MPC Paper No. 2/14
For Consideration by
the Metro Planning Committee on 21.2.2014

FURTHER CONSIDERATION OF THE DRAFT PLANNING BRIEF
FOR THE “COMPREHENSIVE DEVELOPMENT AREA (7)” SITE
AT TSUEN WAN TOWN LOT 393, TSUEN WAN

**Revised Draft Planning Brief for the “Comprehensive Development Area (7)” Site
at Tsuen Wan Town Lot (TWTL) 393, Tsuen Wan**

規劃大綱擬稿的擬議修訂
PROPOSED REVISION TO
DRAFT PLANNING BRIEF

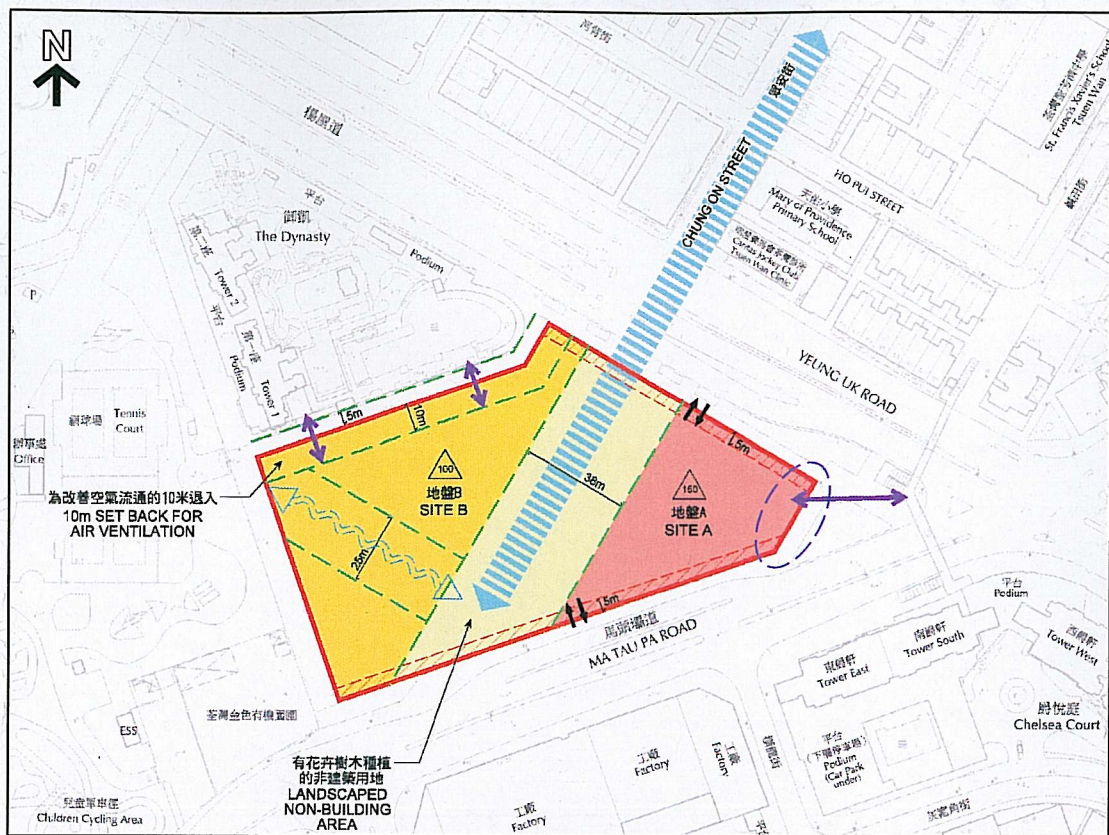
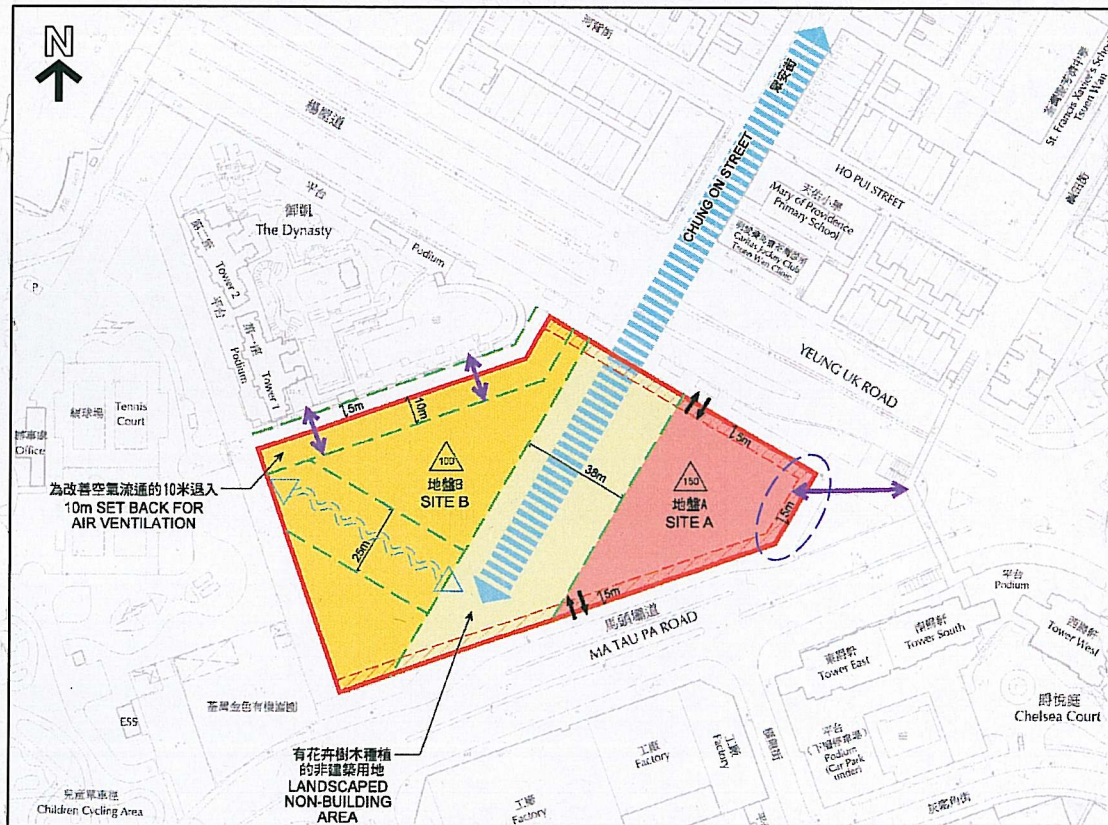
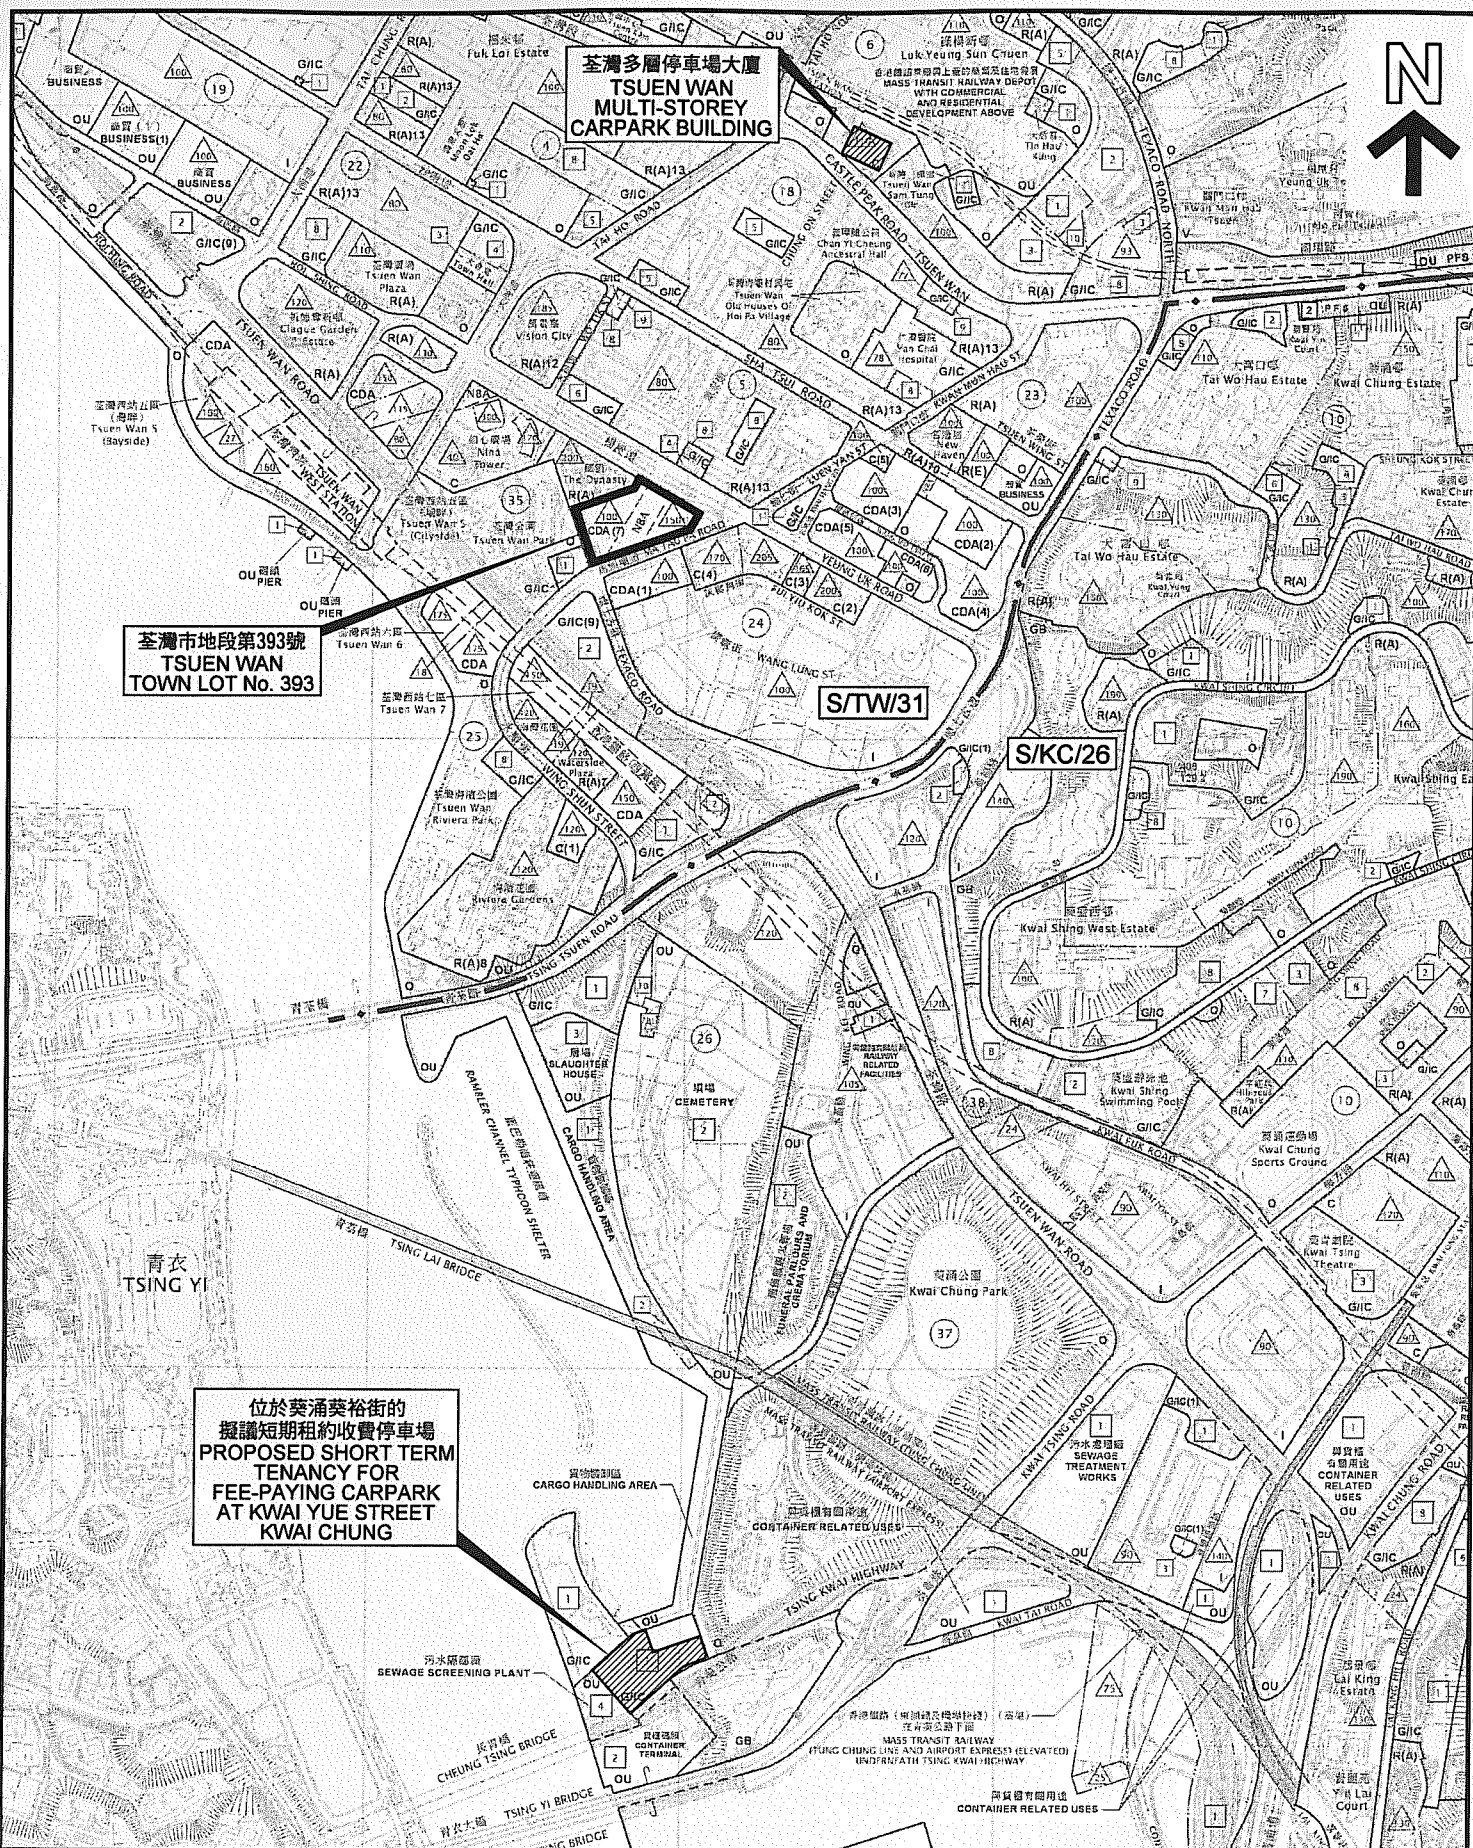
- (e) The building at the eastern corner of the Site (**Annex I**) should also be set back 5m from the junction of Yeung Uk Road and Ma Tau Pa Road.

- (g) Based on our initial assessment, the proposal on building set back of 5m at the eastern corner of the Site (**Annex I**) is feasible without affecting the maximum building height and GFA restrictions for the proposed development. Besides, it will enable continuous planting of trees at regular intervals in the 5m-setback area along Yeung Uk Road and Ma Tau Pa Road to enhance pedestrian environment and streetscape.

- (c) To indicate in **Plan 4** building set back of 5m from the eastern corner of the Site and to stipulate in the PB that the setback is to enable continuous planting of trees at regular intervals along Yeung Uk Road and Ma Tau Pa Road to enhance pedestrian environment and streetscape (under the Items on "Urban Design Considerations" and "Landscape and Tree Preservation Aspects").
